# SAFETY RECALL

Communication #: R-24-02

## SUBJECT: WINCH LOOSE GROUND CONNECTION

# REPAIR PROCEDURE

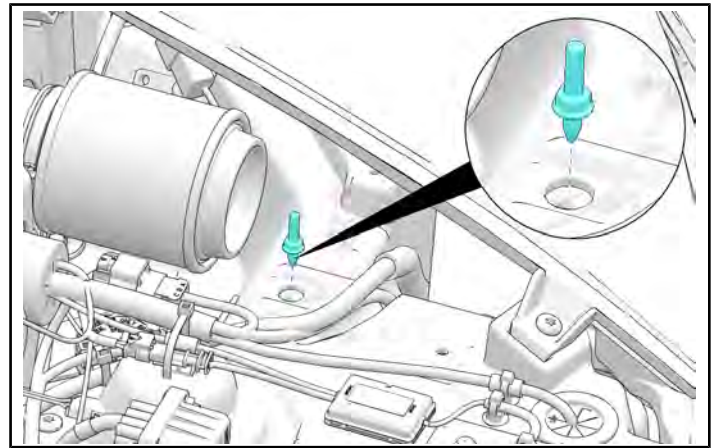
If the under hood liner is contacting the ground stud and preventing it from being removed, remove plastic material until the ground stud can be removed.

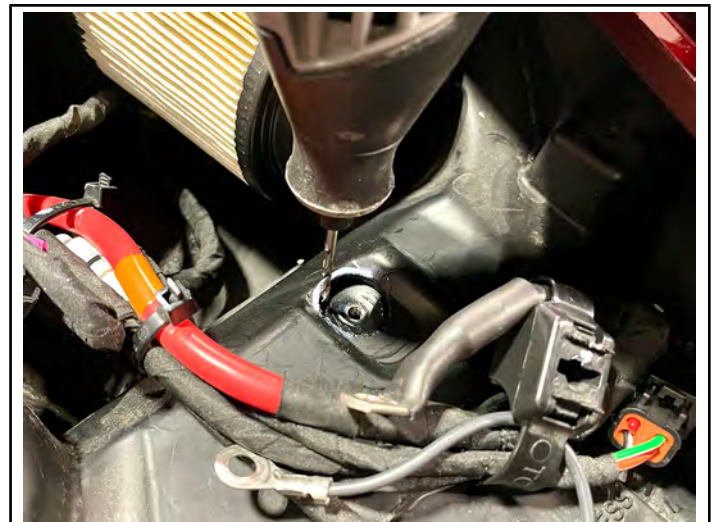
Use a Dremel, 3/4 in (19 mm) hole saw, sharp knife, etc. to remove any material that is inside of the template outline.

Trim plastic hood liner only. Do not damage metal frame underneath or any other nearby components.

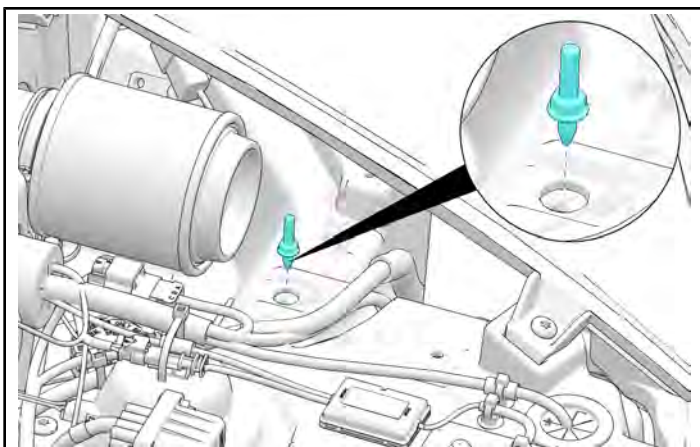
The diameter of the hole should be at least 3/4 in (19 mm) after removing the material.

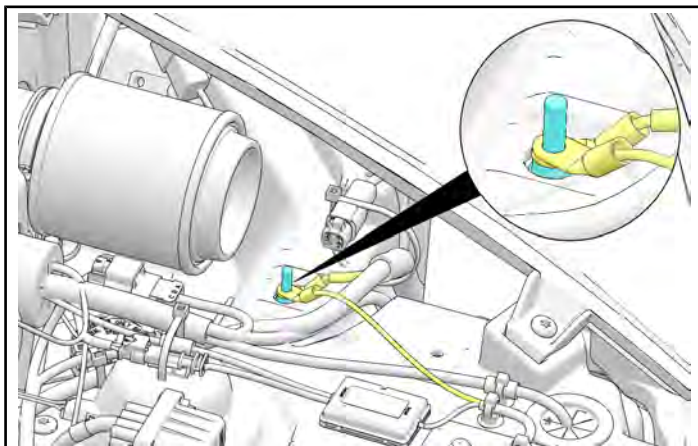
When installing the winch and antenna ground cables onto the ground stud, the winch ground cable must be installed first (on bottom) and followed by the antenna ground cable (on top). Terminals must be offset and clocked so the wire crimps are not immediately on top of each other.

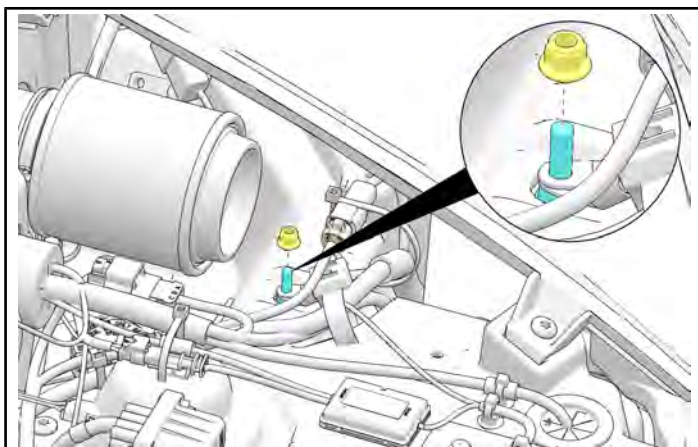
Make sure there is no plastic contacting the ground stud that could be pinched when tightening.

Ground Stud Nut:  
**9 ft-lbs (12 N·m)**
